HISTORIC AND DESIGN REVIEW COMMISSION

Agenda Item No: 29

HDRC CASE NO: 2016-440
ADDRESS: 318 W MISTLETOE
LEGAL DESCRIPTION: NCB 1839 BLK 13 LOT 6
ZONING: R-4 H
CITY COUNCIL DIST.: 1
DISTRICT: Monte Vista Historic District
APPLICANT: Hope Hausman
OWNER: Hope & Stam Hausman
TYPE OF WORK: Window replacement, landscaping
REQUEST:

The applicant is requesting a Certificate of Appropriateness for approval to remove 7 original wood one over one windows on the left and right sides and install vinyl one over one windows with bottom screen, and to remove front lawn and install artificial turf

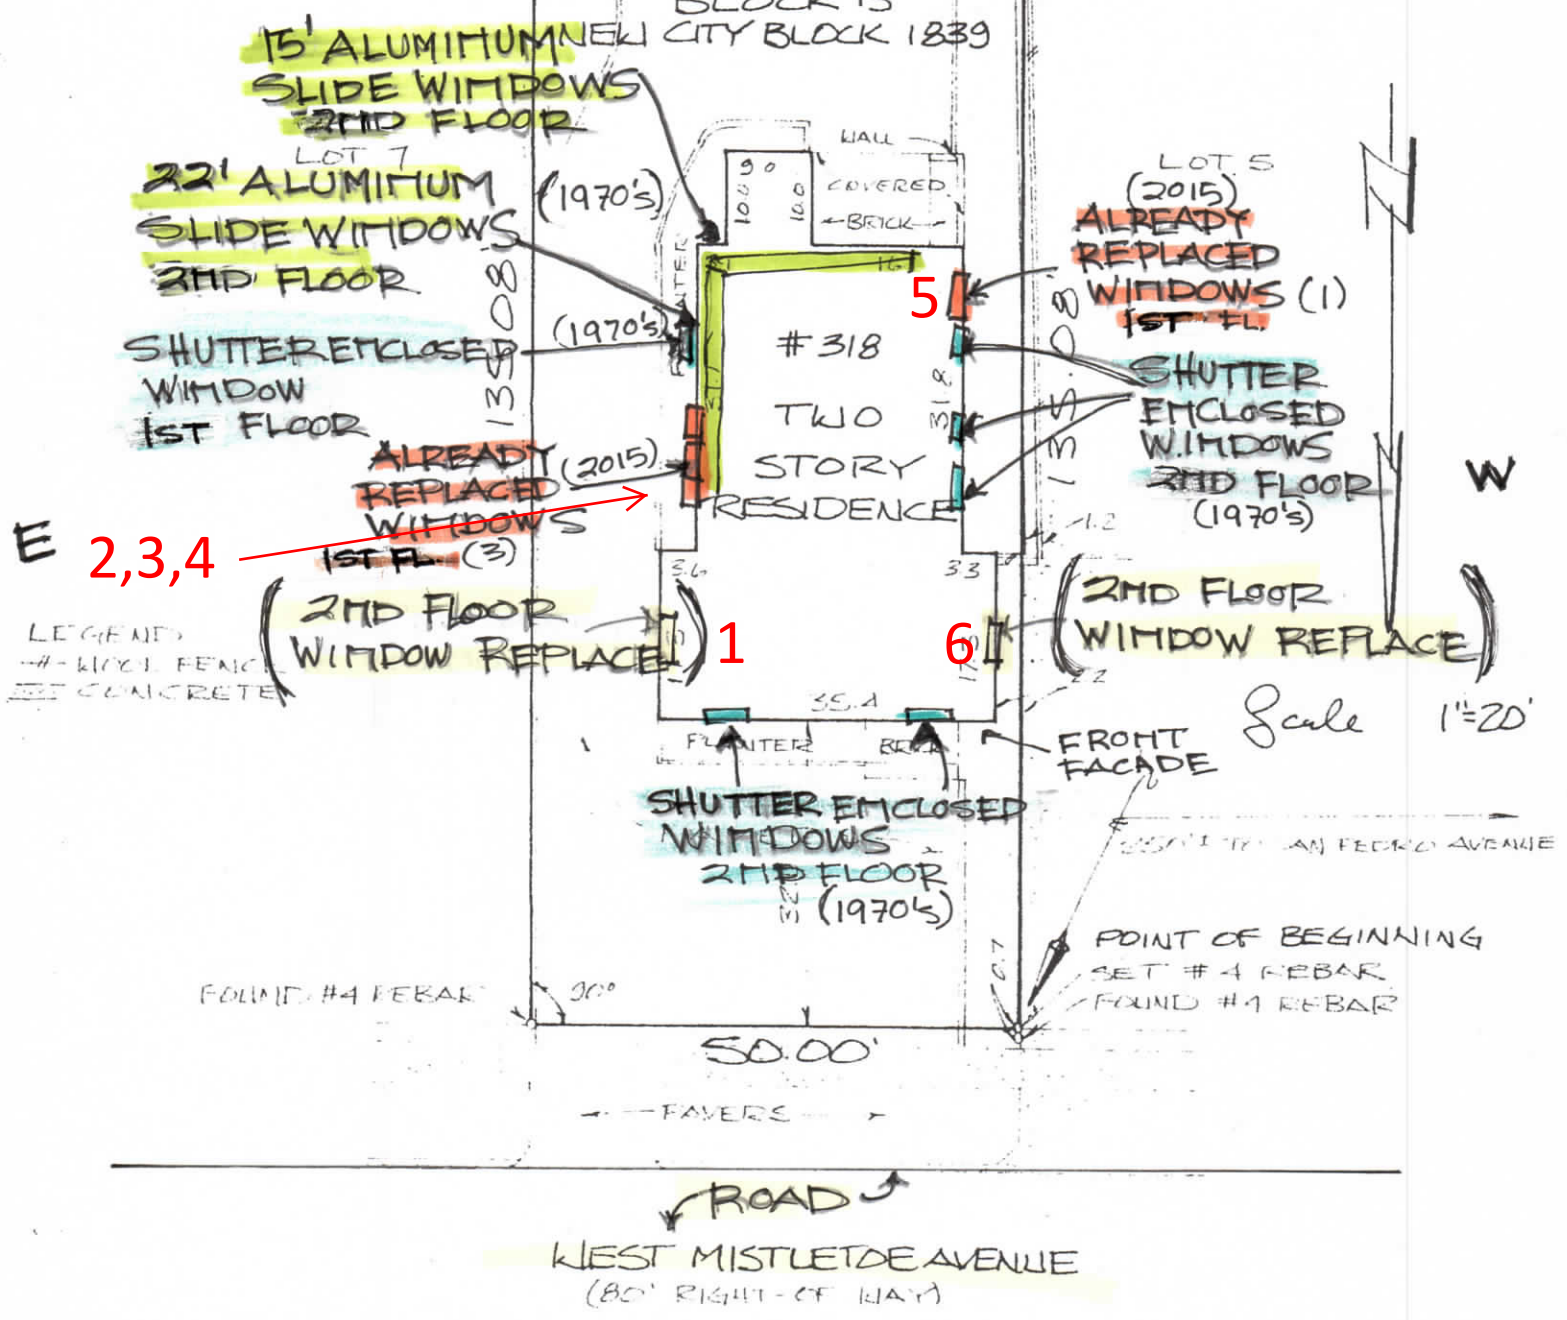
- c. The home has wood one over one windows. The windows to be removed are 7 original wood one over one windows on the left and right sides, and the proposed replacement windows are 7 vinyl one over one windows with a bottom screen. According to the Guidelines for Exterior Maintenance and Alterations 6.B.vii., historic windows should be repaired or, if beyond 50% deteriorated, should be replaced with a window to match the original in terms of size, type, configuration, material and details, feature clear glass, and recessed within the window frame. Windows with a nailing strip are not recommended. The corresponding pages from the adopted windows policy document have been added to the exhibits for this request. Staff made a site visit November 9, 2016, and found that the wood windows are not deteriorated beyond 50%, though the glass is missing. Staff finds the vinyl windows are not an appropriate replacement and recommends that the windows should be repaired. Where the applicant can show to staff that windows are deteriorated beyond repair they should be replaced in-kind.

- d. The proposed turf has been installed without prior approvals and is not appropriate as a substitute for the front lawn.

Staff does not recommend approval of window replacement or turf installation based on findings a through d. Staff recommends that the windows are repaired or replaced in-kind.
